SERVICE BULLETIN**N° 189-090****RECOMMENDED****DATE:** July 25, 2016**REV. :** C - October 16, 2024

TITLE**ATA 71 – NACA COWLING INSPECTION****REVISION LOG**

This Service Bulletin is issued in order to introduce a periodic inspection of the NACA cowling for wear and condition.

Figure 1

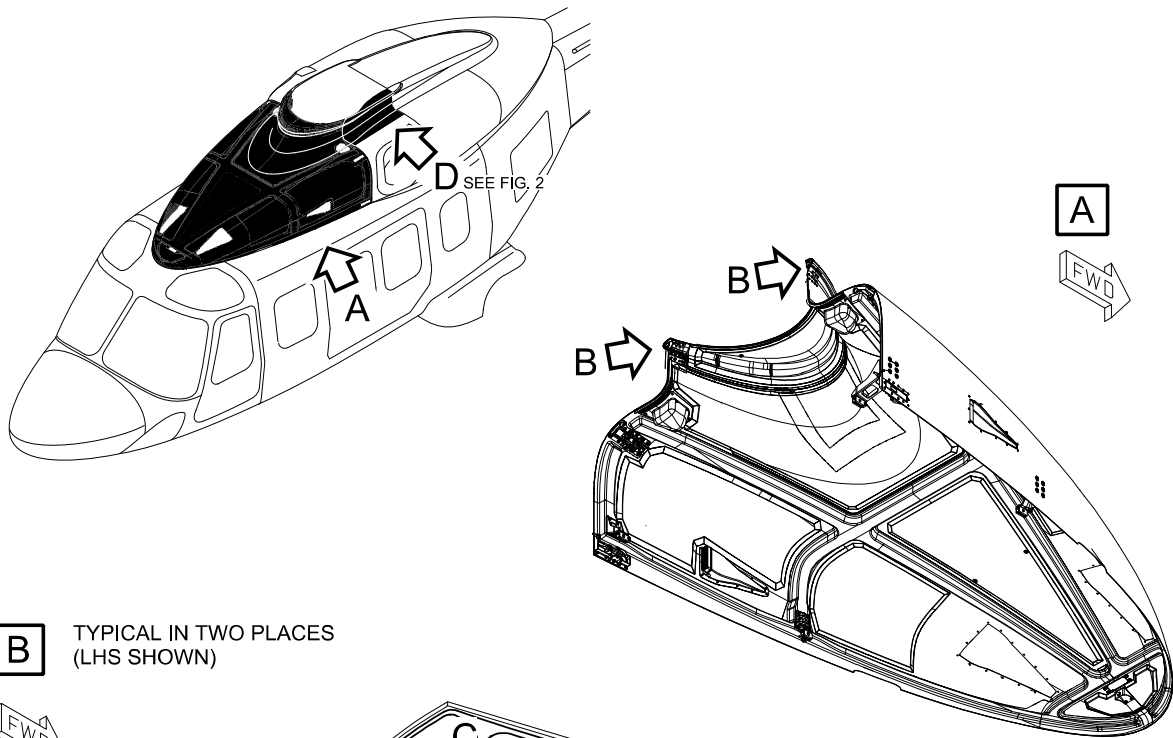
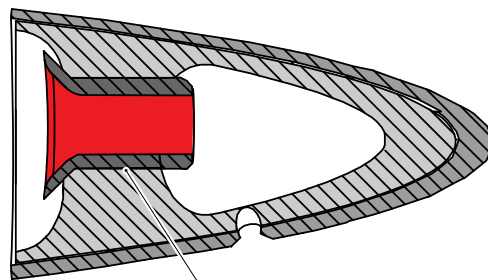
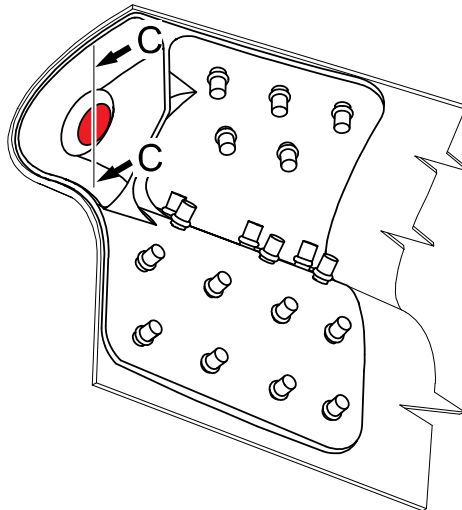
- 4.6 With reference to Figure 3 and Figure 1 Section C, install in position the drilling tool P/N 8G7100G06131 and enlarge the receptacle internal diameter, in the FWD sliding cowling to 15.0 mm.

- 4.7 With reference to Figure 1 Section C, install in the bush P/N 8G7110A20951 in the receptacle by means of adhesive Permabond Flexon F246.
5. Make sure that the reworked receptacle hole is aligned to the pin on the NACA cowling. Adjust the pin position as necessary to avoid interference with the receptacle.

5. With reference to Figure 3 and Figure 1 Section C, install in position the drilling tool P/N 8G7100G06131 and enlarge the receptacle internal diameter, in the FWD sliding cowling to 15.0 mm.

6. With reference to Figure 1 Section C, install in the bush P/N 8G7110A20951 in the receptacle by means of adhesive Permabond Flexon F246.
7. Make sure that the reworked receptacle hole is aligned to the pin on the NACA cowling. Adjust the pin position as necessary to avoid interference with the receptacle.

REWORK:
DRILL PIN RECESS HOLE Ø 15.0
INSTALL:
8G7110A20951 BUSH
USE:
PERMABOND FLEXON F241

Figure 2

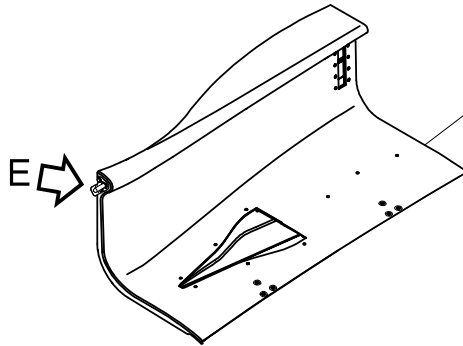
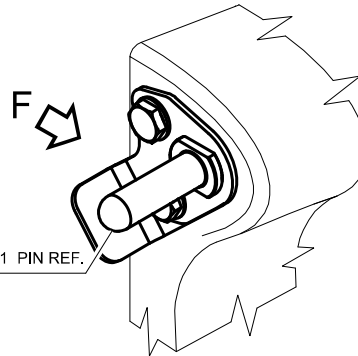
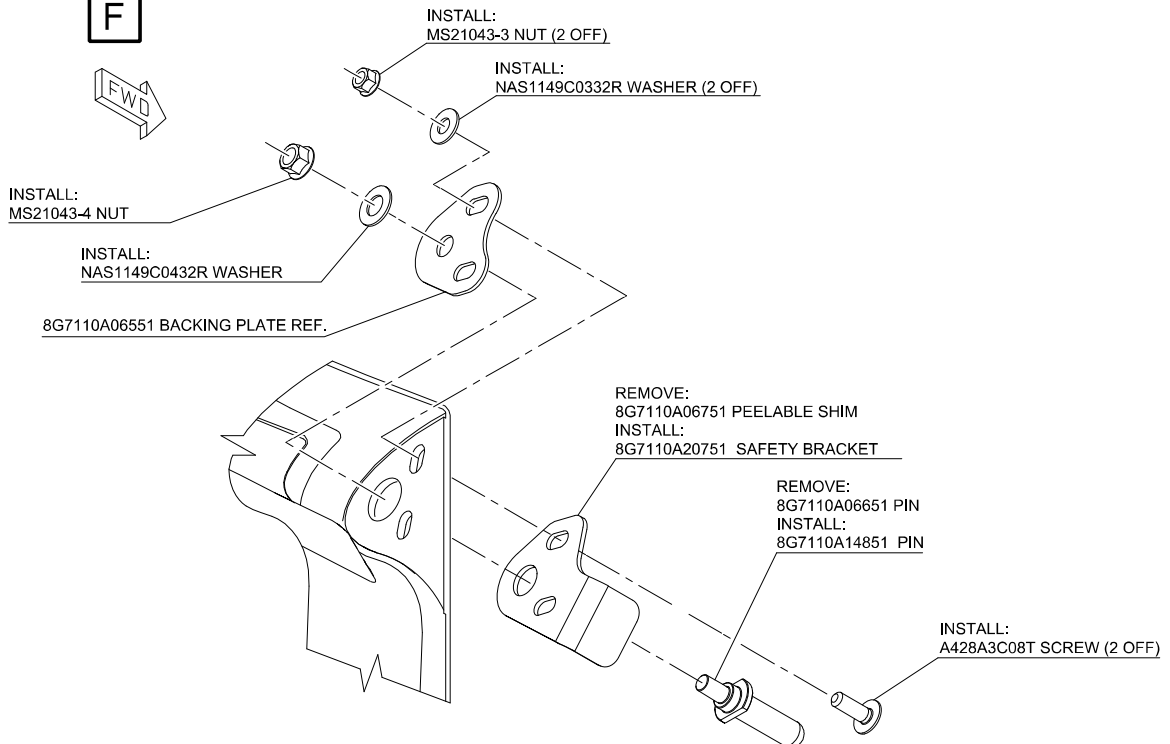
4. With reference to Figures 1 and 2, perform the FWD cowling/NACA cowling pin retromodification P/N 8G7110P01711 in accordance with the following procedure:
 - 4.1 With reference to Figure 2 View F, remove and discard the pin P/N 8G7110A06651 and the existing hardware that attach the pin to the NACA cowling installation LH P/N 8G7110A06831.
 - 4.2 With reference to Figure 2 View F, remove the backing plate P/N 8G7110A06551 and the shim P/N 8G7110A06751. Discard the shim.
 - 4.3 With reference to Figure 2 View F, remove and discard the pin

- 4.4 With reference to Figure 2 View F install a new pin P/N 8G7110A14851 and the new safety bracket LH P/N 8G7110A20751 with existing backing plate P/N 8G7110A06551. Use n°2 screw P/N A428A3C08T, n°2 washers P/N NAS1149C0332R, n°1 washer P/N NAS1149C0432R, n°2 nuts P/N MS21043-3 and n°1 nut P/N MS21043-4.
- 4.5 Make sure that the pin is correctly aligned with the centre of the receptacle hole of the FWD sliding cowling.

Figure 5

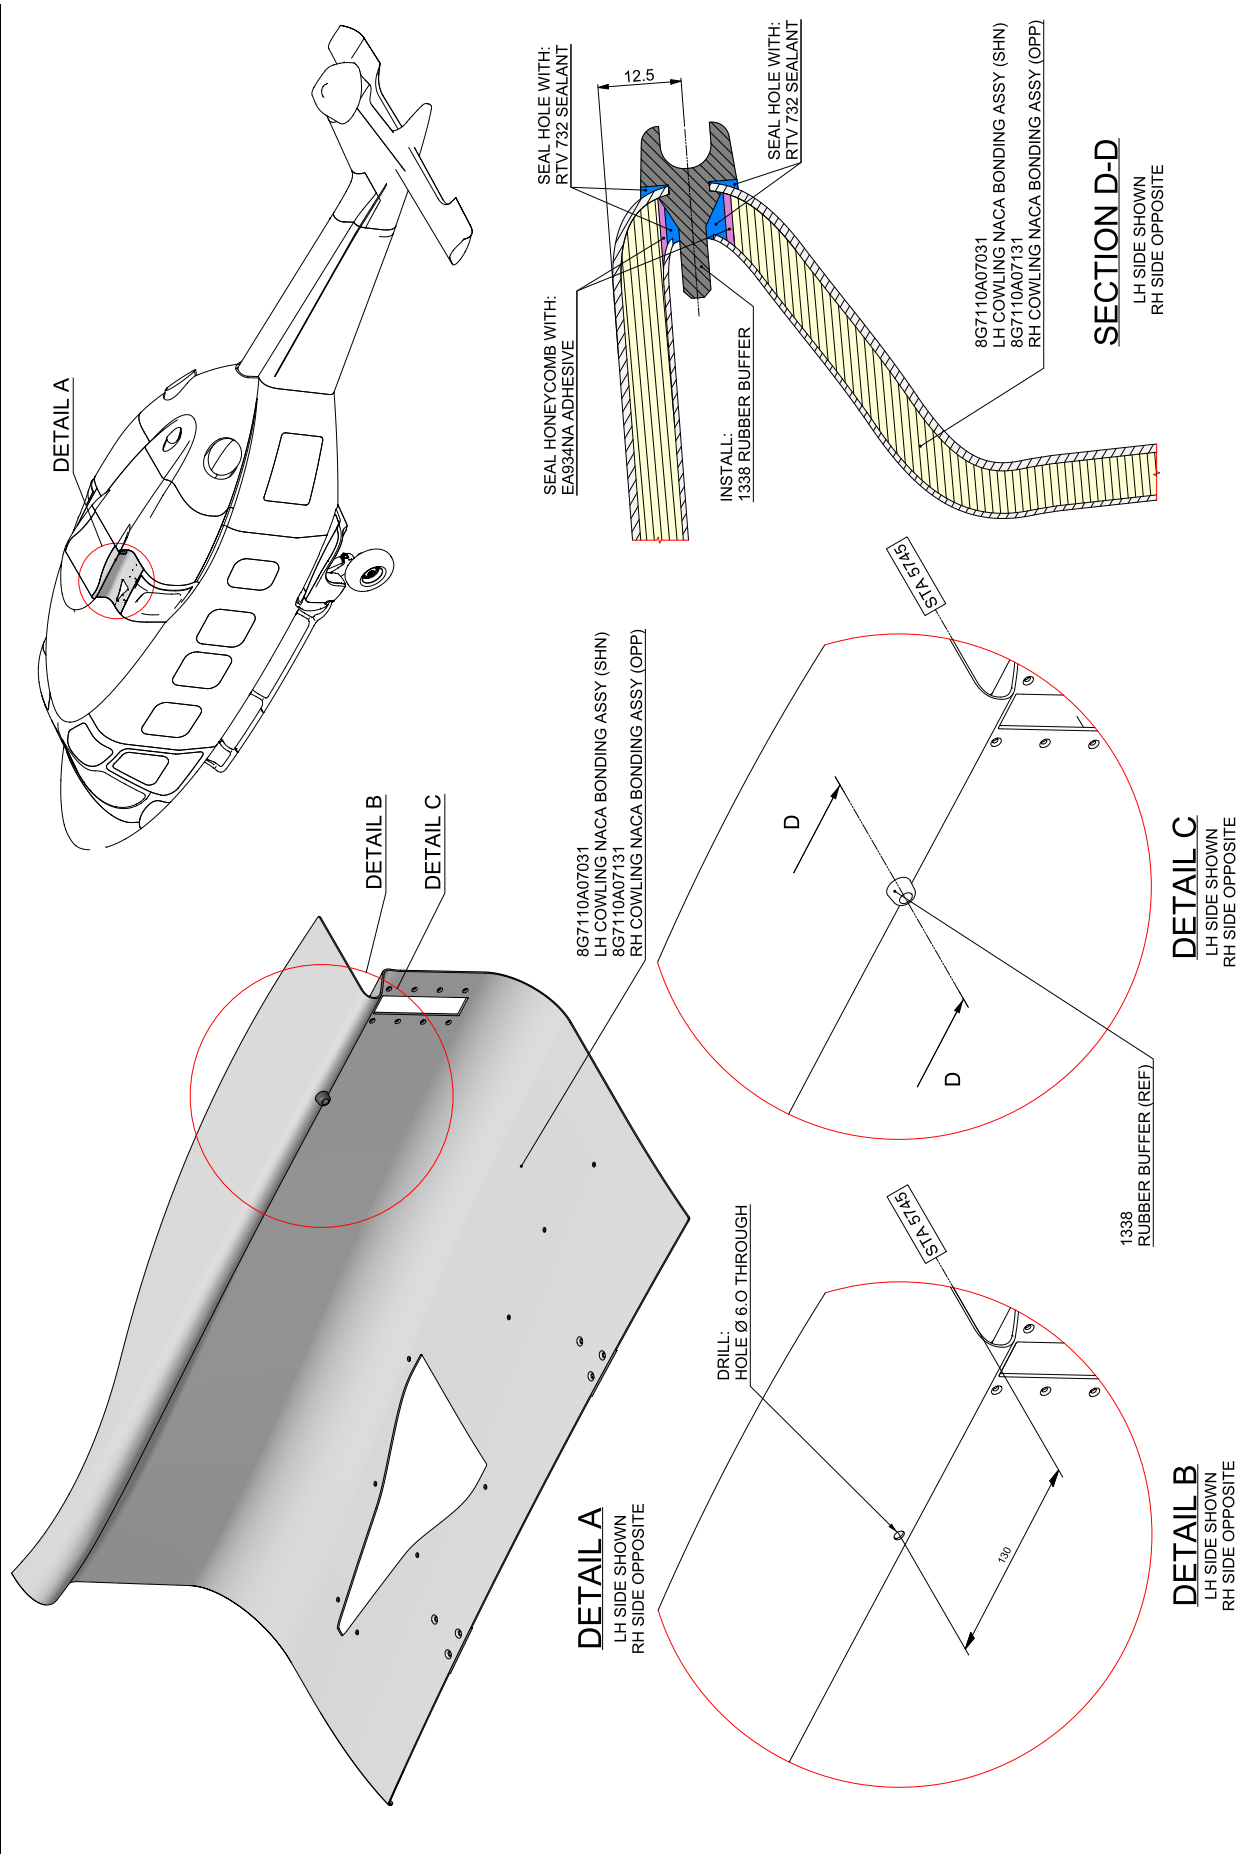
7. With reference to Figure 5 perform the rework of the left cowling NACA bonded assy P/N 8G7110A07031 (access panel 471A), as described in the following procedure:

- 7.1 With reference to Figure 5 Detail B, countermark the position of the hole to be performed in the cowling assy in a position near the contact point countermarked at previous step.

- 7.3 With reference to Figure 5 Detail B, drill n.1 Ø 6.0 hole through the cowling. In accordance with ASRP DM 89-A-ASRP-00-X seal the honeycomb by means of adhesive EA934NA as shown in Figure 5 Section D-D.

- 7.4 With reference to Figure 5 Detail C and Section D-D, install n.1 rubber buffer P/N 1338 by means of adhesive RTV732. Stretch the pin from the inside of the cowling until the anchor head is correctly settled.
